PROPOSED NEW JERSEY RADON RESISTANT SCHOOL CONSTRUCTION CODE

Presented at the 2004 - AARST - 14th Annual International Radon Symposium in Newport, RI

DRAFT RADON HAZARD SUB-CODE FOR SCHOOLS

Comments about the possible changes to the draft are included as underlined text.

Figure 1

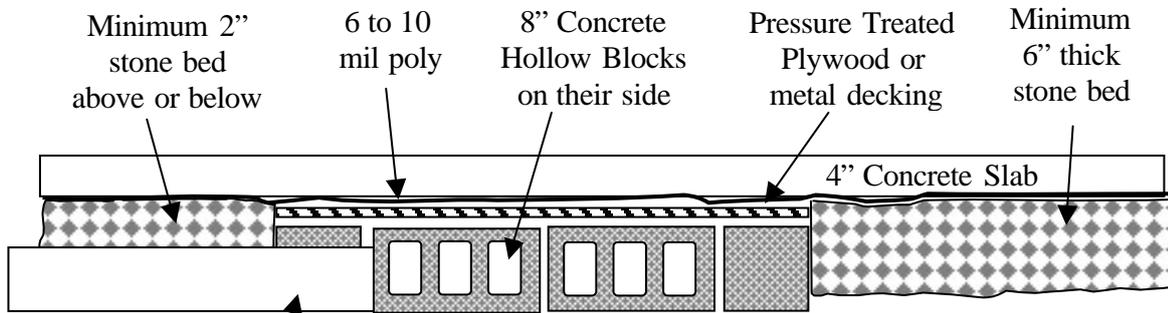
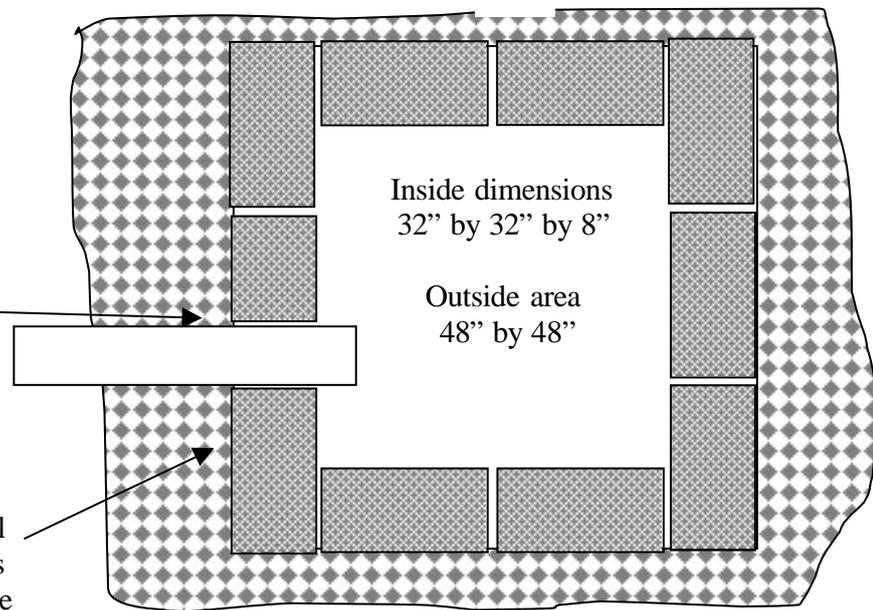
6" solid schedule 40 pvc pipe routed from collection box to the roof

Chip out block to allow 6" PVC pipe to pass into the plenum

375 si of actual opening versus 28 si for 6" pipe

Figure 3

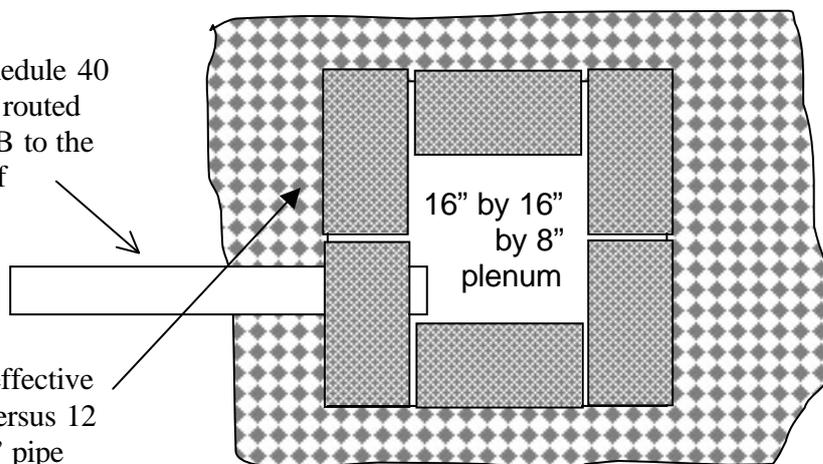
Gravel beds under 4000 sf

4" solid schedule 40 pvc pipe routed from RnCB to the roof

175 si of effective opening versus 12 si for 4" pipe
